Subject: Application To Revise Technical Specifications to Adopt TSTF-545,
Revision 3, "TS Inservice Testing Program Removal & Clarify SR Usage
Rule Application to Section 5.5 Testing"

Pursuant to 10 CFR 50.90, Exelon Generation Company, LLC (EGC) is submitting a request for an amendment to the Technical Specifications (TS) for Braidwood Station, Units 1 and 2; Byron Station, Units 1 and 2; Calvert Cliffs Nuclear Power Plant, Units 1 and 2; Clinton Power Station, Unit 1; Dresden Nuclear Power Station, Units 2 and 3; LaSalle County Station, Units 1 and 2; Nine Mile Point Nuclear Station, Units 1 and 2; Peach Bottom Atomic Power Station, Units 2 and 3; Quad Cities Nuclear Power Station, Units 1 and 2; R.E. Ginna Nuclear Power Plant; and Three Mile Island Nuclear Station, Unit 1.

The proposed change revises TS Section 5.5, or equivalent, "Inservice Test Program." A new defined term, "INSERVICE TESTING PROGRAM," is added to the TS Definitions section. This request is consistent with TSTF-545, Revision 3, "TS Inservice Testing Program Removal & Clarify SR Usage Rule Application to Section 5.5 Testing."

INSERVICE TESTING PROGRAM

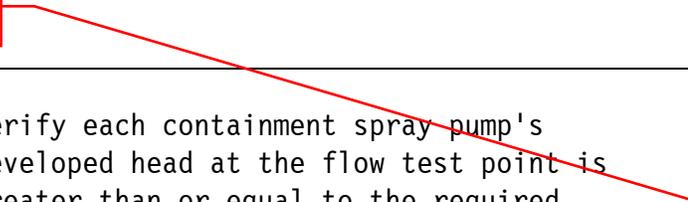
<u>Valve Number</u>	<u>Position</u>	<u>Function</u>	MOV-659	Open	Mini-flow Isolation	MOV-660	Open	Mini-flow Isolation	CV-306	Open	Low Pressure Safety Injection Flow Control	In accordance with the Surveillance Frequency Control Program
<u>Valve Number</u>	<u>Position</u>	<u>Function</u>												
MOV-659	Open	Mini-flow Isolation												
MOV-660	Open	Mini-flow Isolation												
CV-306	Open	Low Pressure Safety Injection Flow Control												
SR 3.5.2.2	<p>----- NOTE ----- Not required to be met for system vent flow paths opened under administrative control. -----</p> <p>Verify each ECCS manual, power-operated, and automatic valve in the flow path, that is not locked, sealed, or otherwise secured in position, is in the correct position.</p>	In accordance with the Surveillance Frequency Control Program												
SR 3.5.2.3	Verify each high pressure safety injection - and low pressure safety injection pump's developed head at the test flow point is greater than or equal to the required developed head.	In accordance with the Inservice Testing Program												
SR 3.5.2.4	Deleted

SR 3.5.2.4

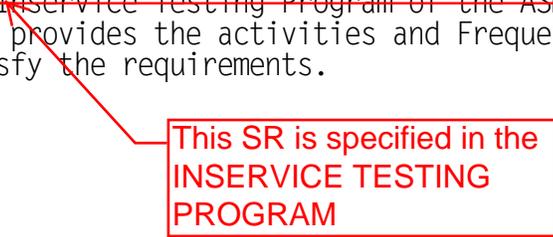
Periodic surveillance testing of ECCS pumps to detect gross degradation caused by impeller structural damage or other hydraulic component problems is required by the ASME Code. This type of testing may be accomplished by measuring the pump developed head at only one point of the pump characteristic curve. This verifies both that the measured performance is within an acceptable tolerance of the original pump baseline performance and that the performance at the test flow is greater than or equal to the performance assumed in the plant safety analysis. ~~SRs are specified in the Inservice Testing Program of the ASME Code.~~ The ASME Code provides the activities and Frequencies necessary to satisfy the requirements.

This SR is specified in the
INSERVICE TESTING
PROGRAM

SR 3.0.2

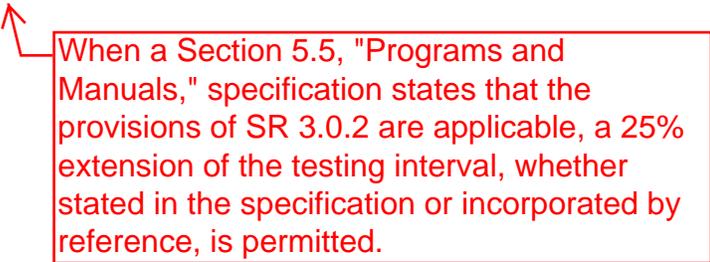
SR 3.0.2 permits a 25% extension of the interval specified in the Frequency. This extension facilitates Surveillance scheduling and considers unit operating conditions that may not be suitable for conducting the Surveillance (e.g., transient conditions or other ongoing Surveillance or maintenance activities).

When a Section 5.5, "Programs and Manuals," specification states that the provisions of SR 3.0.2 are applicable, a 25% extension of the testing interval, whether stated in the specification or incorporated by reference, is permitted.

B 3.0 SURVEILLANCE REQUIREMENT (SR) APPLICABILITY

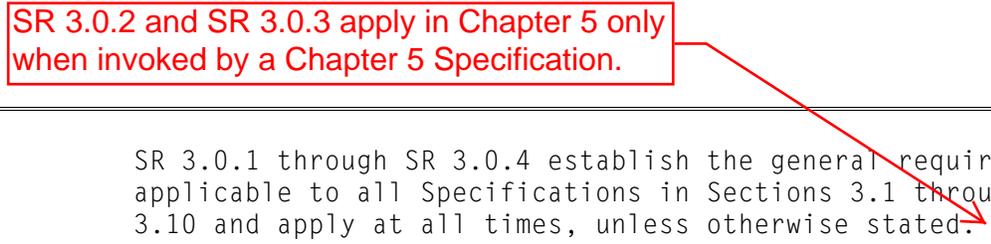
SR 3.0.2 and SR 3.0.3 apply in Chapter 5 only when invoked by a Chapter 5 Specification.
